SEAT LEON CUP RACER 2016

TECHNICAL NOTE 07/2016

View of the new rear diffuser support.

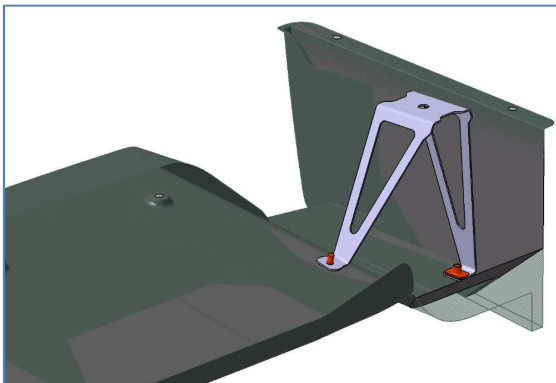
SEAT Sport has improved the rear diffuser fixation. We recommend mounting in all existing cars with 2016 aero. (New cars or updated cars)

- For diffusers produced from week 21 (15th of May) forwards have already drilled the fixation holes on the diffuser, so plug and play.
- On the previous production diffuser is the customer who has to drill the fixation hole on the diffuser. To do it, place the diffuser + the new supports on its natural position and proceed to mark and drill.
- Tightening torque: By hand + Loctite 342 blue.
